**A&M Project #:** 2889-01  
**Re:** Skyview Estates  
Preliminary Subdivision  
Peer Review  
651 Main Street  
Map 21/Parcel B5.1

Please find Allen & Major Associates, Inc. (A&M) responses to the Preliminary Plan Review dated May 6, 2021 as prepared by Quinn Engineering, Inc., in reference to their review of Skyview Estates Preliminary Subdivision to be located at along Main Street in Leicester, Massachusetts

DRAWING TITLE: PROPOSED SUBDIVISION PLAN  
SHEET No. C-101

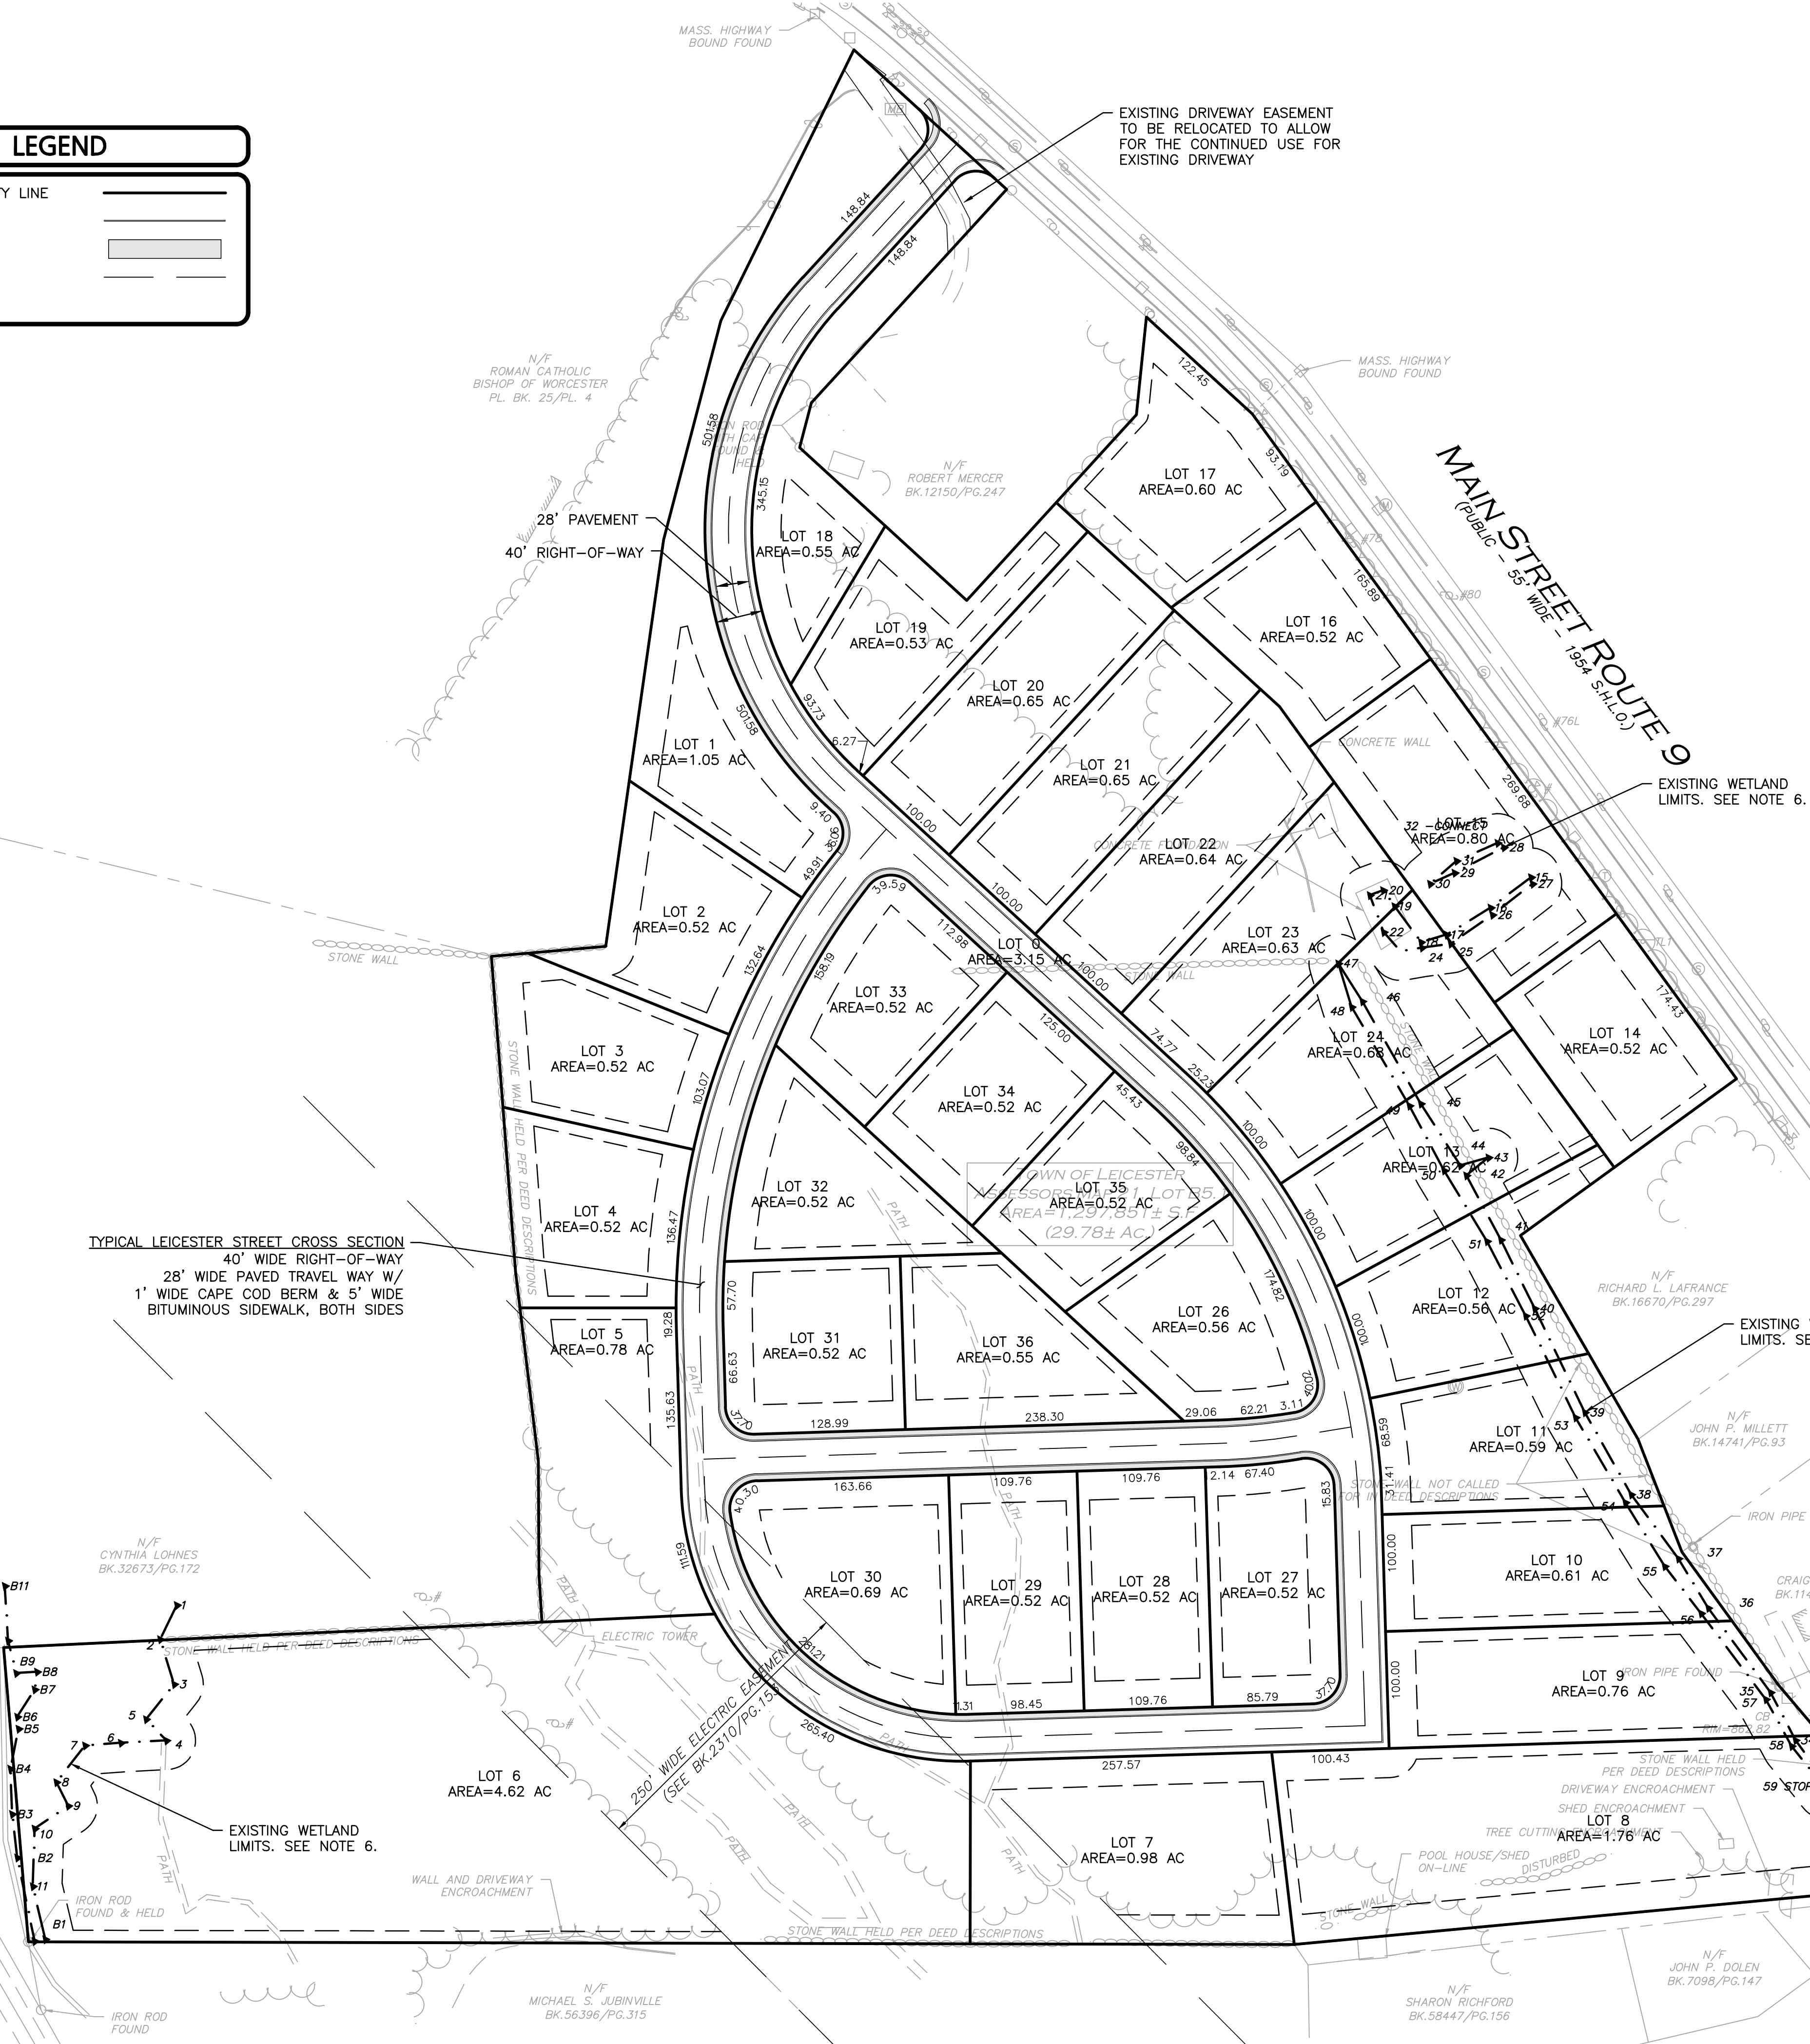
1. *The existing driveway easement serving #747 Main Street must be labeled. (III.2.b.4)*

2. *The Applicant must identify the distance between the proposed roadway and the existing intersection of Main Street and Waite Street. Street jogs with centerline offsets of 125 feet should be avoided. (V.A.1.e)*

4. *A 50 foot leveling area has not been provided from the sideline of Main Street along Alignment 6 and has not been provided from the sideline of Alignment 6 along Alignment 8. (V.A.3.b)*

9. *Lots 12, 23, 24 and 25 do not meet the minimum frontage requirement. (V.G.)*

**Response: The existing driveway easement has been labeled on the plans.**

**Response: The distance to the existing intersection has been shown on the plans and is approximately 165'**

**Response: Currently, a portion of the leveling pad is included in the sag curve geometry, however can be adjusted to provide a full 50 foot level area along Main Street. A level 50 foot area has been provided along Alignment 8 to the side line of Alignment 6.**

**Response: The plans have been updated to provide the minimum frontage.**

DRAWING TITLE:	SHEET No.
GRADING & DRAINAGE PLAN	C-102

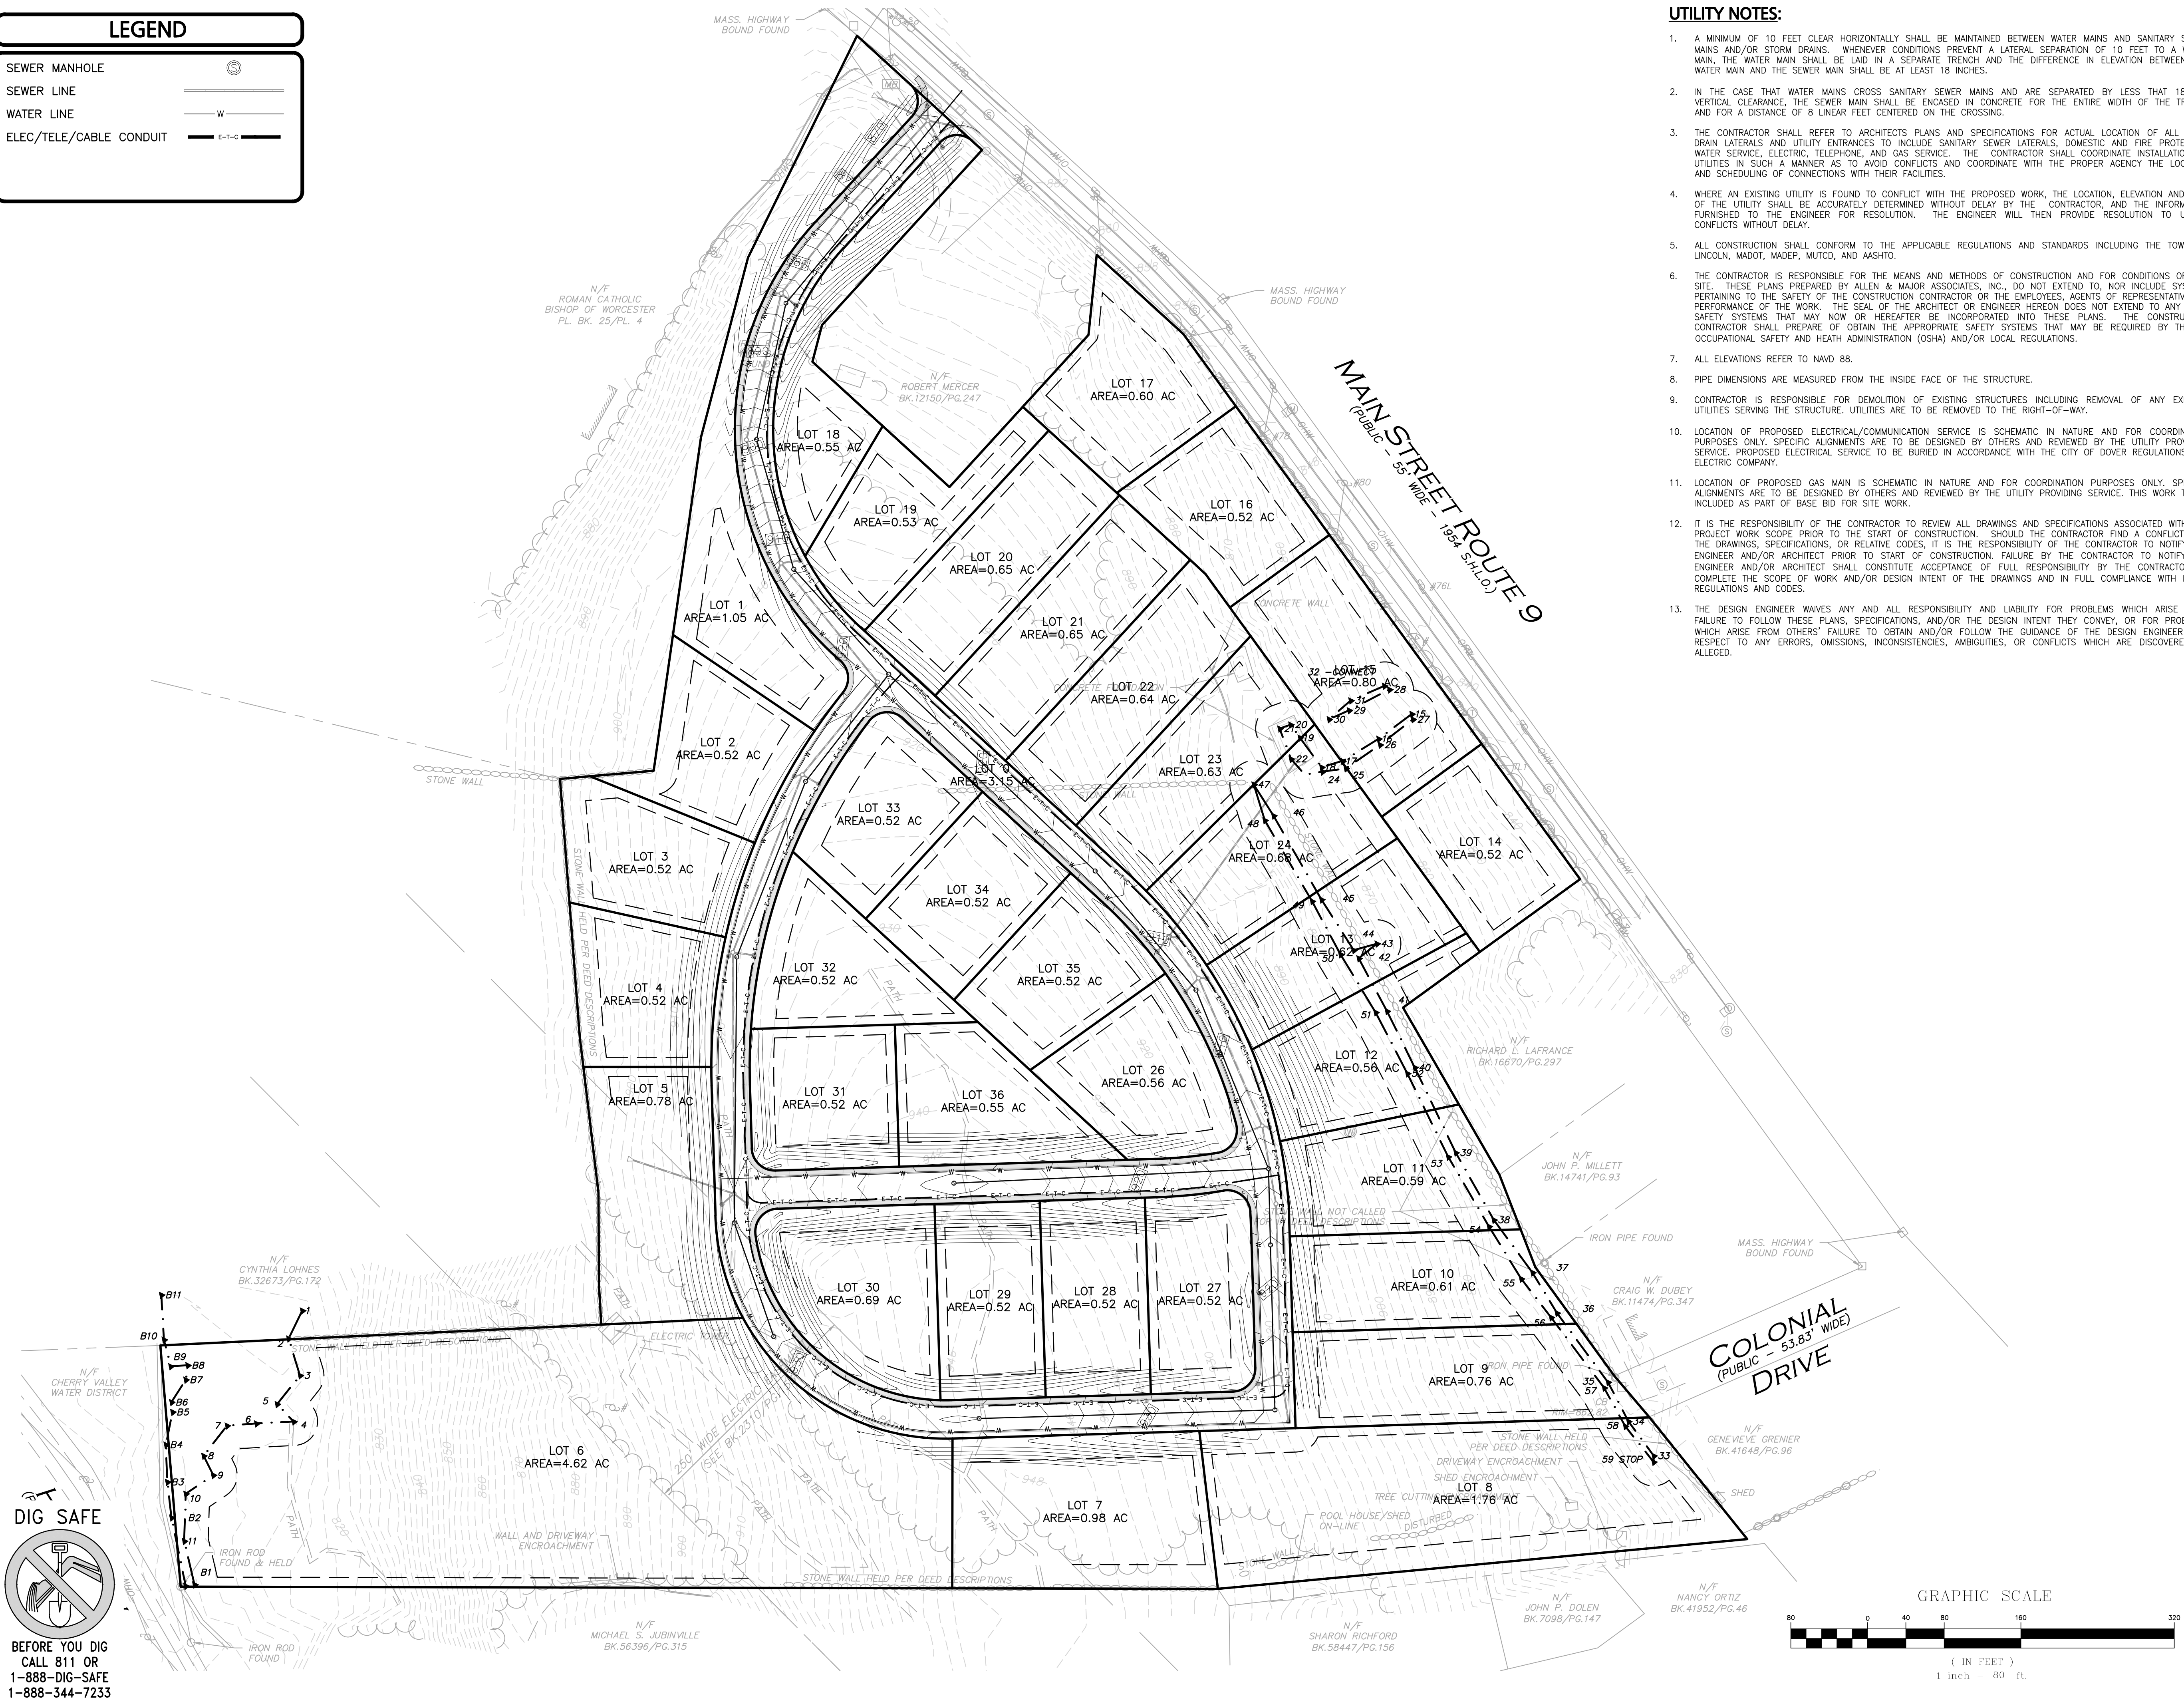
19. Note 8 on Sheet C-102 should be revised to reflect the 2 foot contour interval provided on the plans.

**Response:** The note has been updated.
